HISTORIC AND DESIGN REVIEW COMMISSION

June 05, 2019

HDRC CASE NO: 2019-310
ADDRESS: 1431 W ROSEWOOD AVE
LEGAL DESCRIPTION: NCB 2766 BLK 71 LOT 17 AT 1431 ROSEWOOD AVE W
ZONING: R-4,H
CITY COUNCIL DIST.: 1
DISTRICT: Keystone Park Historic District
APPLICANT: Paul Peralez
OWNER: Paul Peralez/PERALEZ PAUL A & RAMOS MOSES
TYPE OF WORK: Window replacement
APPLICATION RECEIVED: May 13, 2019
60-DAY REVIEW: July 12, 2019
CASE MANAGER: Stephanie Phillips
REQUEST:

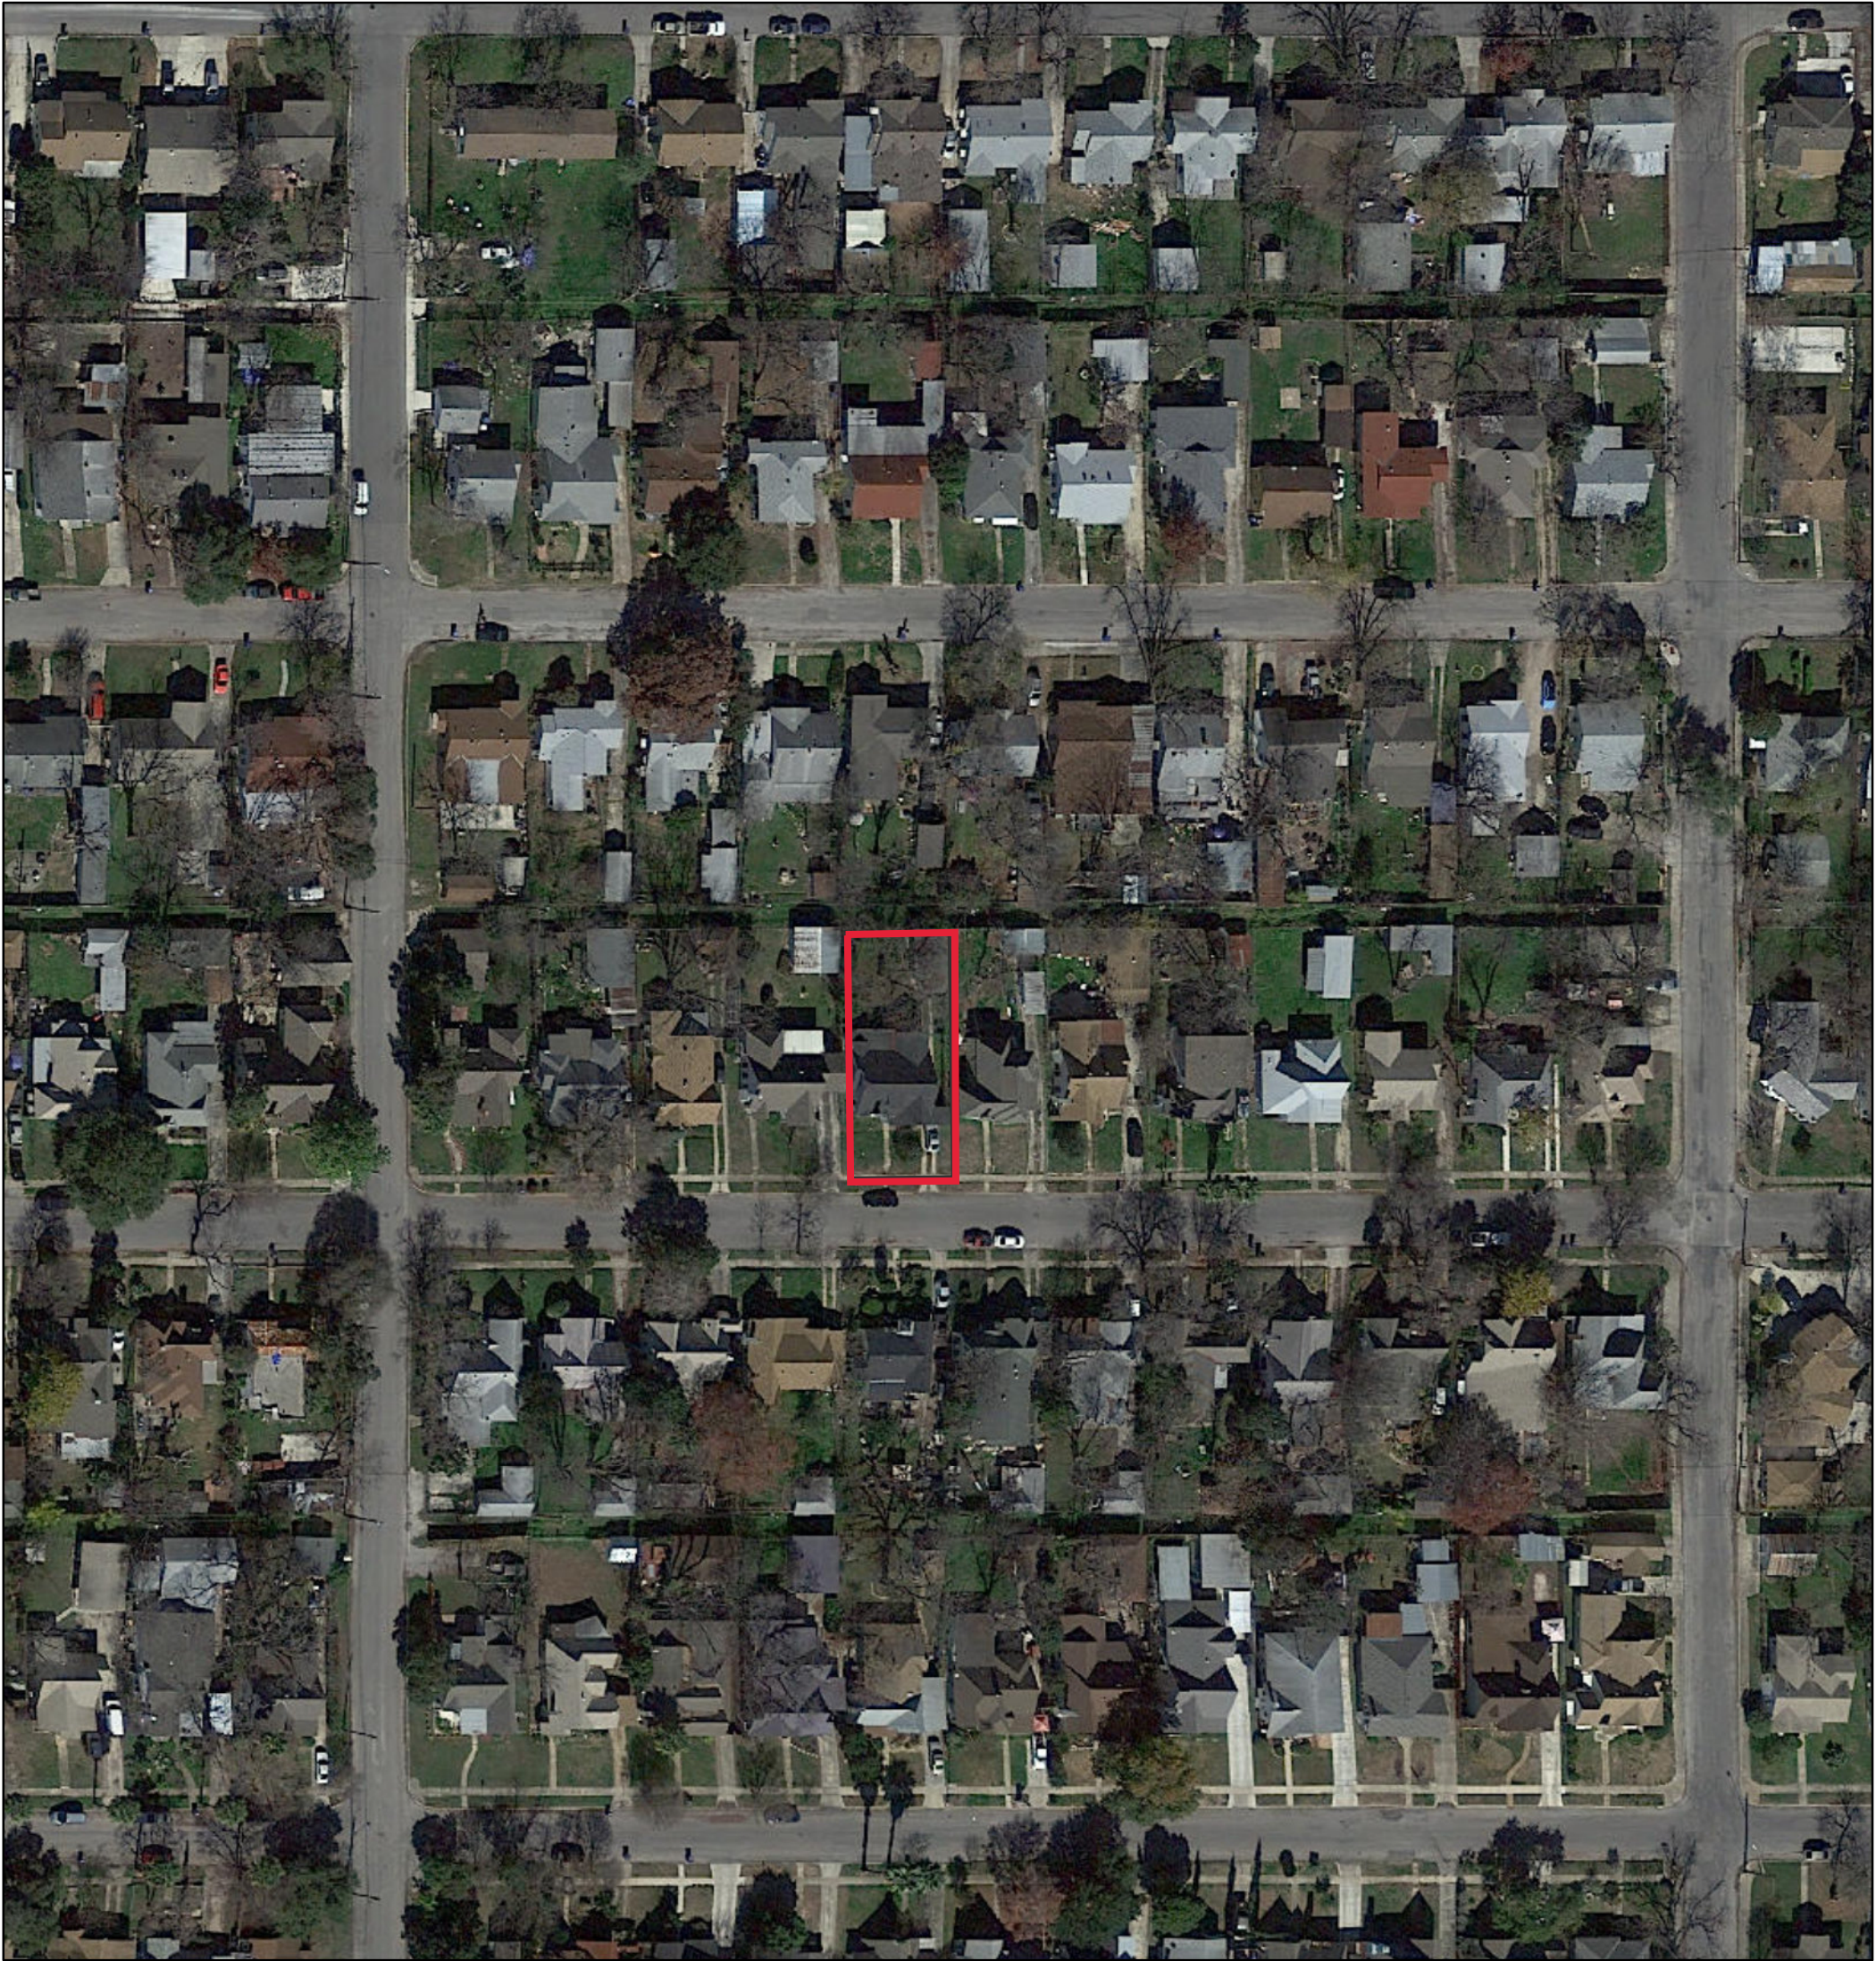
- b. **EXISTING WINDOWS: CONDITON** – The applicant provided several photographs of the existing windows taken from outside the home. Based on the photographic evidence provided, staff finds that the wood windows are in good condition and are fully repairable. In general, staff encourages the repair of historic wood windows. A wood window that is maintained over time can last for decades. Replacement window products have a much shorter lifespan and cannot be repaired once they fail.

- c. **WOOD WINDOW WINDOW REPLACEMENT** – According to the Guidelines for Exterior Maintenance and Alterations 6.A.iii., and 6.B.iv., in kind replacement of windows is only appropriate when the original windows are beyond repair. As noted in finding b, staff does not find the original windows to be beyond repair. Replacement of any kind is not consistent with the Guidelines.

- d. **ALUMINUM WINDOW REPLACEMENT** – These windows are not consistent with the Guidelines nor the OHP Window Policy Document. According to the Guidelines for Exterior Maintenance and Alterations 6.A.iii., and 6.B.iv., in kind replacement of windows is only appropriate when the original windows are beyond repair or are no longer present in the structure. The applicant has proposed to install new Pella brand one over one wood windows that are consistent with the Guidelines. Staff finds the proposal appropriate.

Item 1, Staff does not recommend approval of the original wood window replacement based on findings a through c. Staff recommends that the applicant repair the existing wood windows in place. If there are assemblies that are deteriorated beyond repair, the applicant must submit evidence to that effect to staff in the form of a window schedule and photographs. If an assembly is deemed deteriorated beyond repair by staff, staff recommends that new windows meet the following stipulation:

- i. That the applicant installs one-over-one wood windows to match the existing configuration as closely as possible. Vinyl or composite windows are not appropriate. Meeting rails must be no taller than 1.25” and stiles no wider than 2.25”. There should be a minimum of two inches in depth between the front face of the window trim and the front face of the top window sash. This must be accomplished by recessing the window sufficiently within the opening or with the installation of additional window trim to add thickness. The final specification should be submitted to staff for review prior to the issuance of a Certificate of Appropriateness.

Item 2, Staff recommends approval of the non-original replacement based on finding d.
